TO	
COMPANY	
FAX NUMBER	13018165100
FROM	RochesterFax
DATE	2019-09-23 12:27:09 EDT
RE	Rotork Part 21 Fax to NRC

**Please find Attached a Part 21 notification from Rotork Controls Inc.  
concerning a safety related "Outer Clutch Ring", part number N40039.**

Subject: NA Actuator, Model NA1, Outer Clutch Ring Anomaly

Fig 1

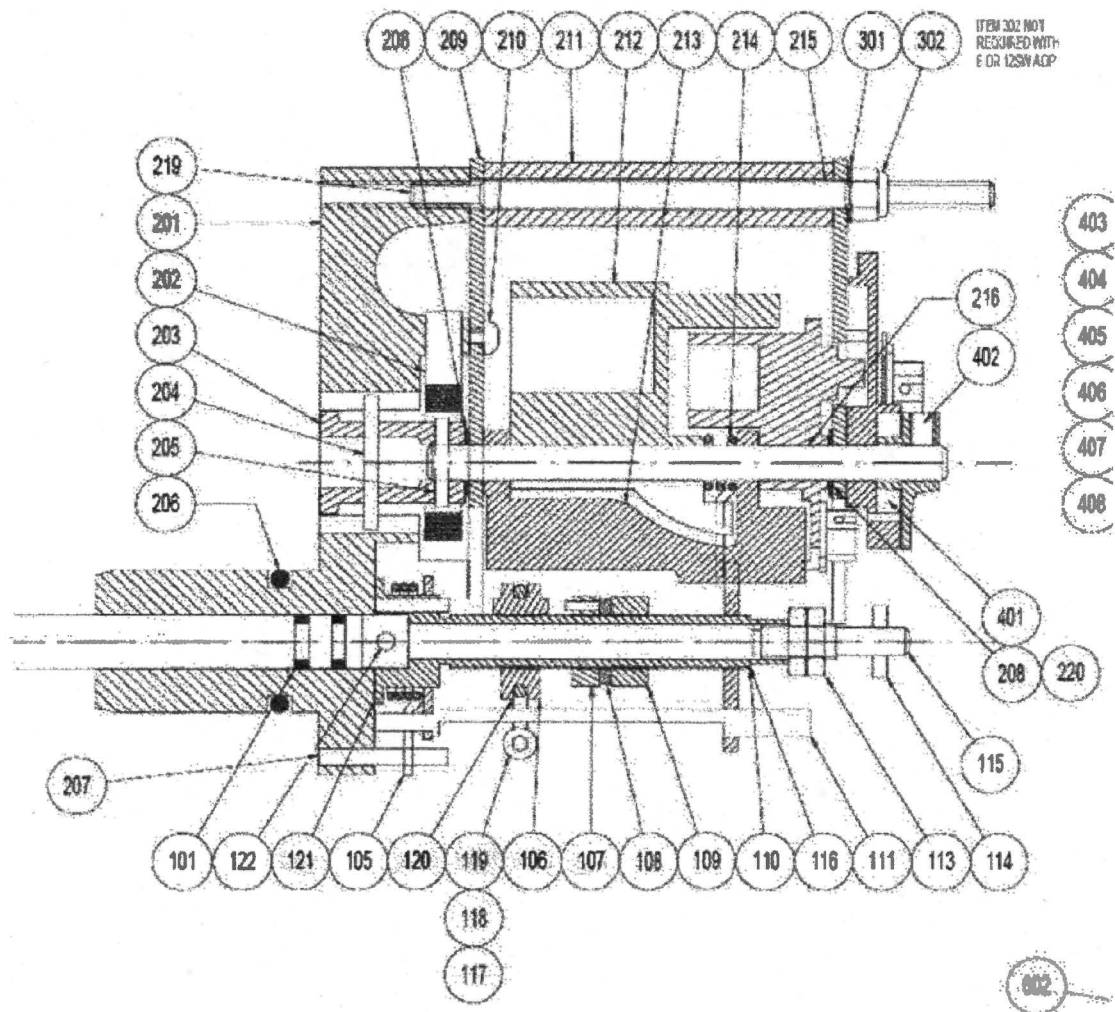
Failure of the Outer Clutch ring prevents the actuator from stopping on travel limit. Should this occur the actuator will over travel and eventually stop on output torque limit set by the customer. The Outer Clutch Ring (Fig1, 120) wraps around a component called the inner traveler (Fig 1, 106) and prevents it rotating until it reaches the set travel limit position (Fig 1, 107 & 121). The Outer Clutch Ring slips on the inner traveler if necessary. Slip in service should not occur. Slip may occur during commissioning and test.

The cause of the component failure is not understood. All failures occurred at the same point in the component. The form of the fractures are similar (Fig 2). The Outer Clutch Ring is seated onto the inner traveler by initially over tightening the cap-screw (Fig 1, 119) used to set the torque at which the Outer Clutch Ring slips on the inner traveler. Over tightening to seat may have introduced a weakness. The same method is used to seat spring steel Outer Clutch Rings. There are no records of

Rotork have developed a repair kit (WN 84122) which replaces the beryllium copper Outer Clutch Ring with a spring steel version.
